MEMORANDUM

TO: Water Right File 63-12253, 63-12254, 63-12255, and 63-33938

FROM: Daniel Nelson – Analyst 3

SUBJECT: Licensing Review of Water Rights 63-12253, 63-12254, 63-12254, and 63-33938

License Review Map Permits 63-12253, 63-12254, 63-12255, and 63-33938.

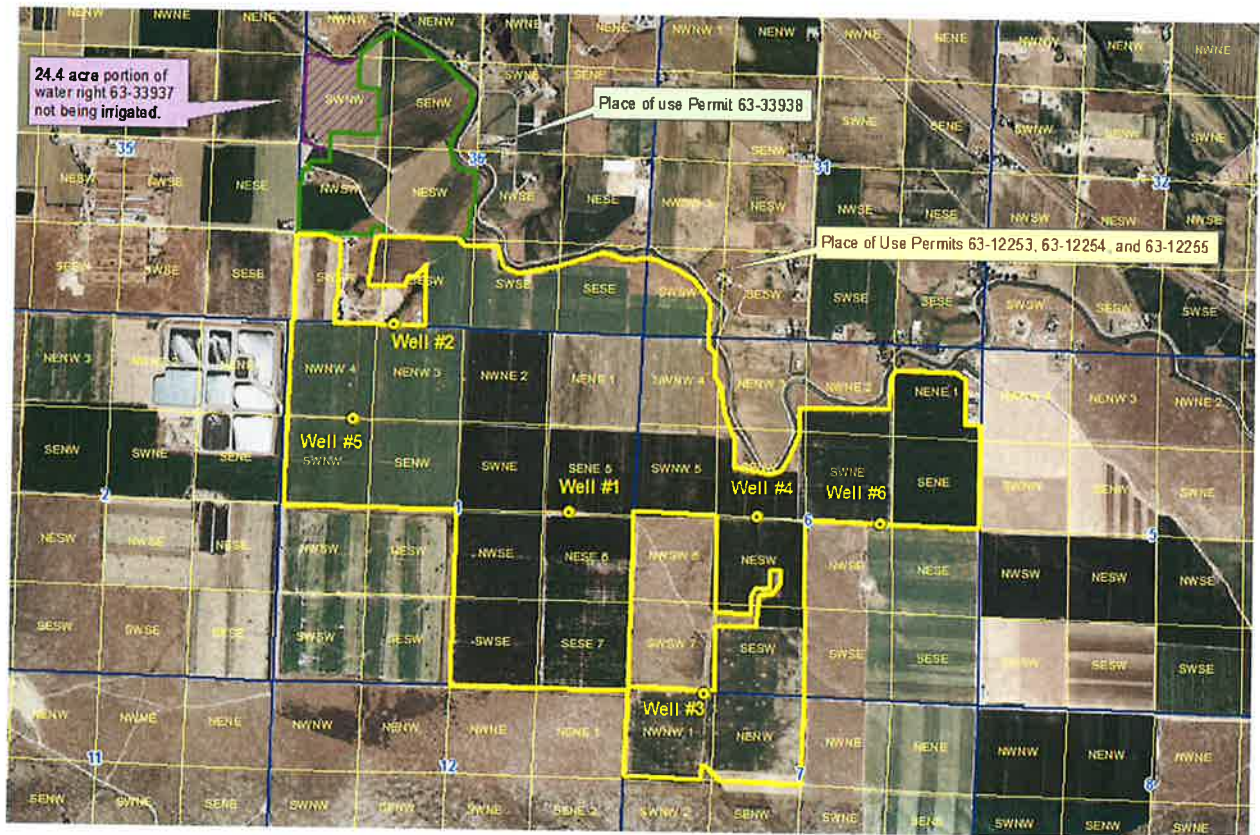
The area outlined in the yellow border is the South Farm, which has a 1003 acre Permissible Place of Use. The South Farm is the place of use for permits 63-12253, 63-12254, and 63-12255. The area outlined in Green is the place of use for the North Farm, and is the place of use for permit 63-33938. The purple area is the 24.4 acres not irrigated by water right 63-33938, but is covered by water right 63-33937. The 24.4 acres are in the process of being sold, and haven't been irrigated since approximately 2008. The 6 yellow dots are the points of diversion for both farms and all four permits.
